CITY OF SACRAMENTO

Permit No: 9811129

Site Address: 1620 9TH AV SAC

Nature of Work: ADD168SQ FT &REM/(N) BATH&(N) HALL&TILE KIT

Scale 7/8" ALL
Floor Plan of Addition

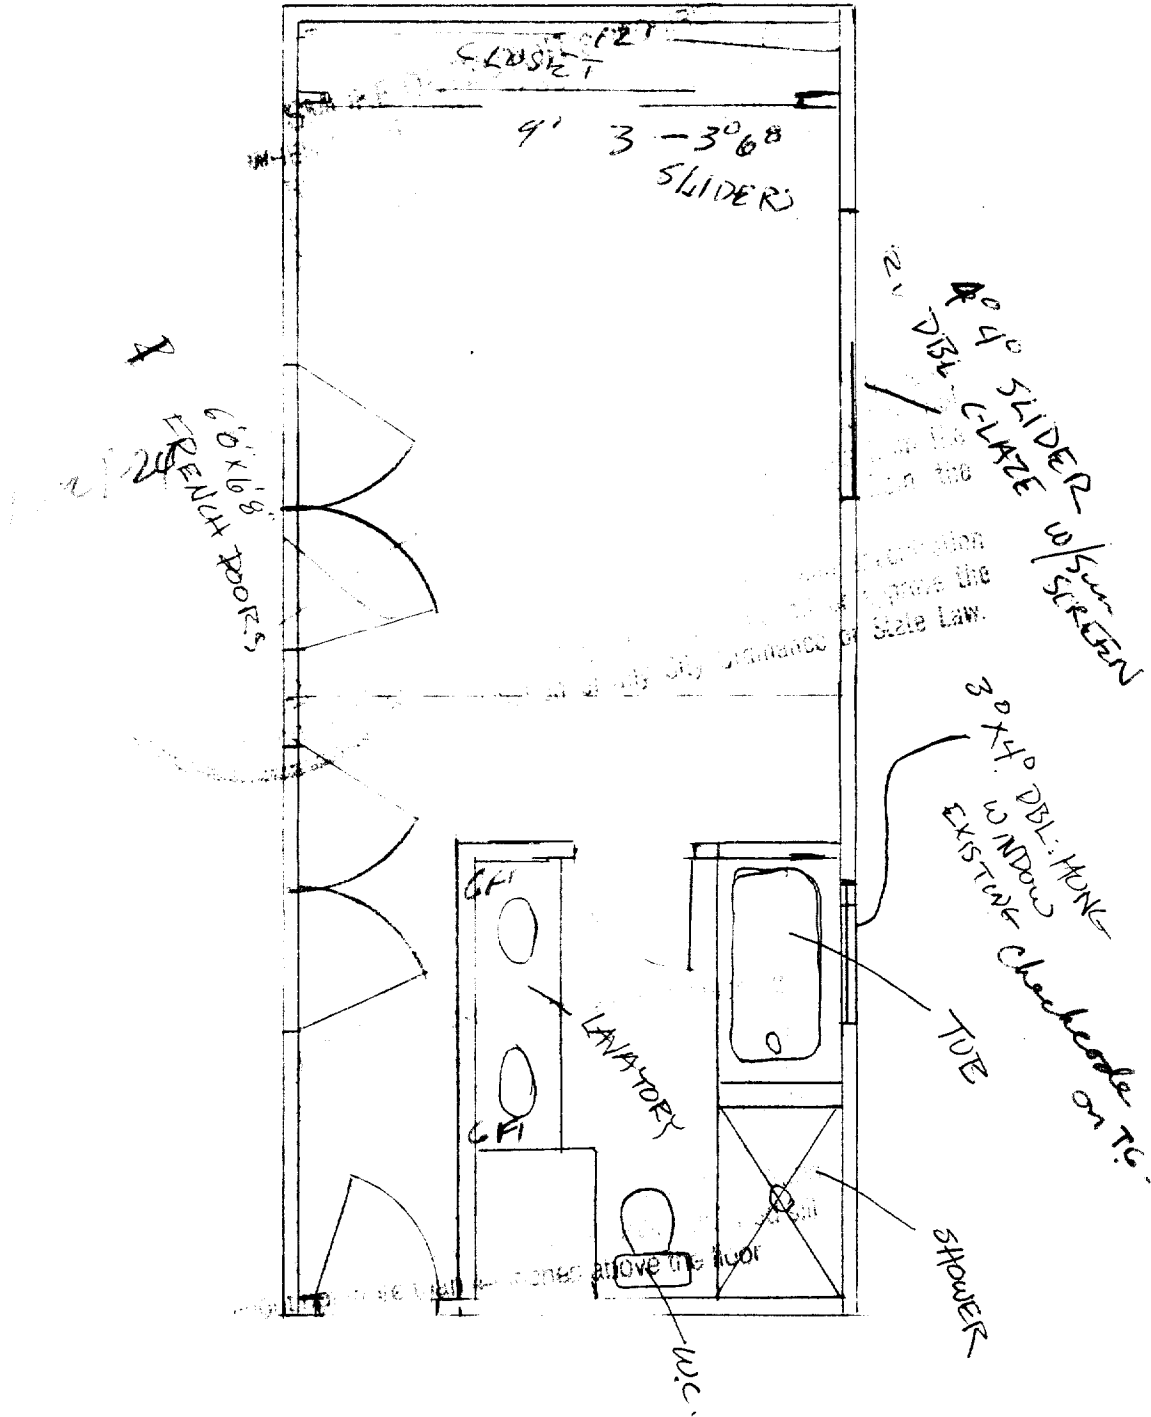
Scale of
2 1/2" Max glass in addition = 16 sq

will give credit for
removed glass
